Technical modifications and updating of the spare parts catalogue baby 43

→ Starting from serial number: 14000115 dated 15/01/14 - table 1304-10 R00

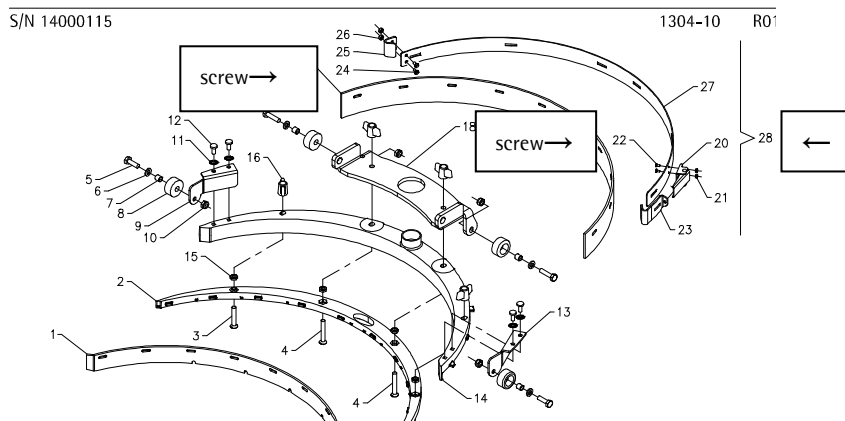
We replace the screws, pos. 22 and 24 with longer ones, because they did not stick out sufficiently from the nut.

Take off:

60170305 screw M2,5x6 UNI 7688 INOX

Add:

60170306 screw M2,5x8 UNI 7688 INOX

If during maintenance the screws are replaced, we recommend to use some blocking liquid at the reassemblage.

We have added position 28 of the rear rubber blade assembly having number V8313010.

The rear squeegee rubber of 33shore is available to improve drying on 10x10 tiles with large joints. The part number is: 48413050.

Table 1305-20, R00, pos. 3

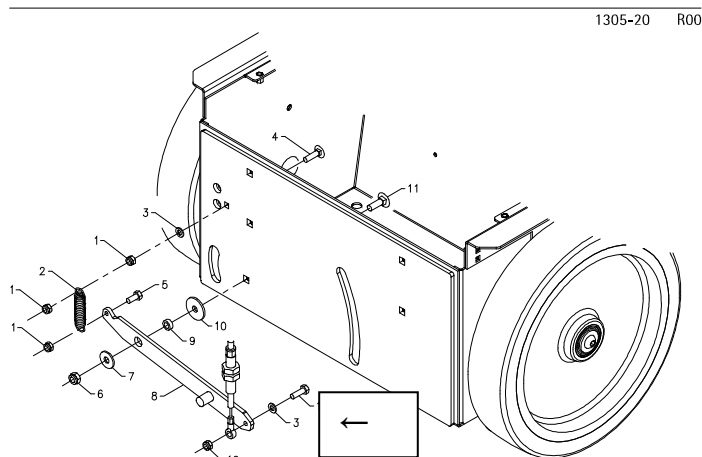
We have added a washer with part number 60305002 between the screw pos. 13 and the lifting lever, pos. 8.

→ Starting from serial number: 14000252 dated 05/02/14 - table 1309-20 R00, pos. 14

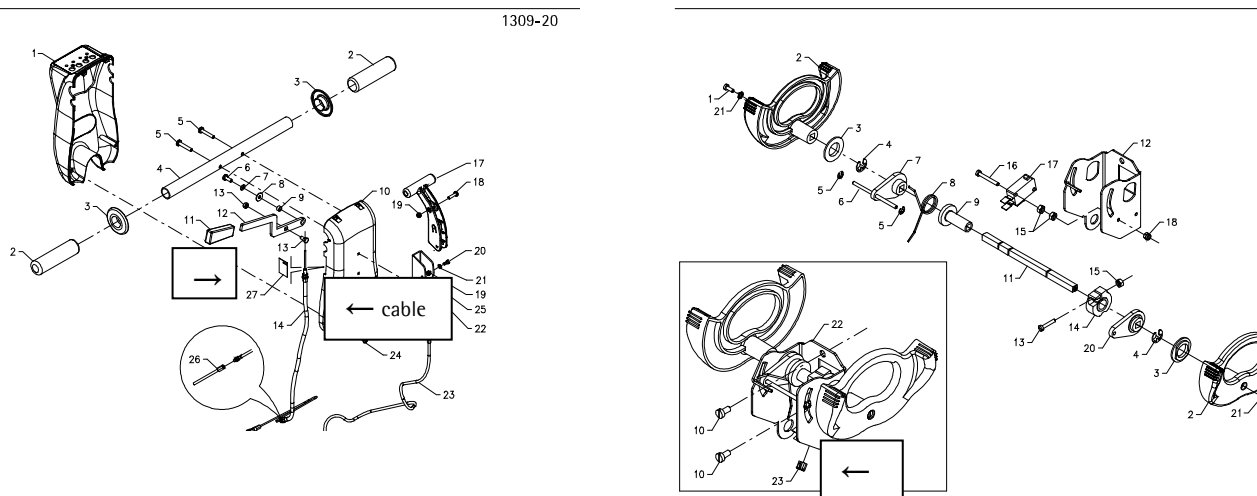
To simplify the assembly of the handle bar cable (21309020) it has been lengthened of 25mm. Once it has been assembled, it is necessary to refold it to avoid that it interferes with the drive control.

Table 1310-20 R00

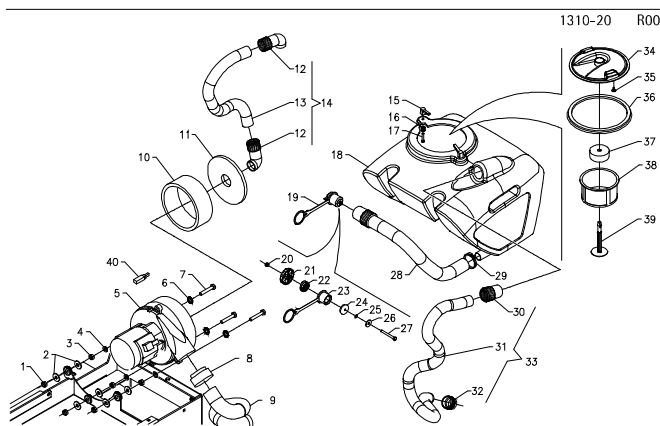
We have added different part numbers starting from position 30.

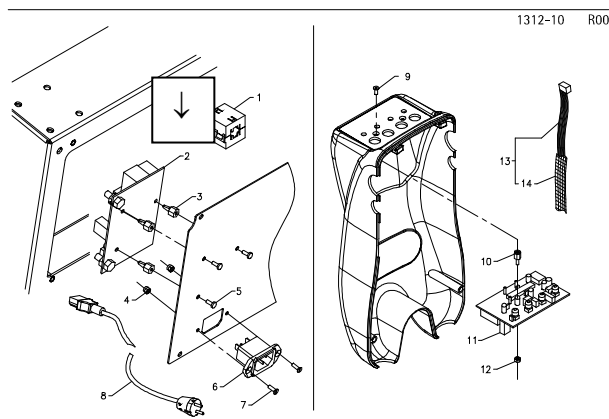
→ Starting from serial number: 13004575 dated 07/12/13 – table 1312-10 R00, pos. 2
The check card relay 49705050 with brush motor relay of 40A has the condenser of 45μF on the 40A-relay. Because of some breakdowns we have replaced the 45μF condenser with a 150μF one. The check cards are interchangeable with the previous ones.

→ Starting from serial number: 14000253 dated 05/02/14 – table 1312-10 R00, pos. 2
The check card relay is turned upside down to avoid the possibility of short circuits. The position of the check card on the rear panel is modified, it is rotated of 180° to avoid while taking off the panel that the battery cable connections are going to touch accidentally the frame plate. The intervention may be applied also to the existing machines carrying out the holes for the new fixing position of the check card relay. The part number of the panel (21301020, table 1312-20 R00, pos. 2) remains unchanged and is interchangeable with the previous one.
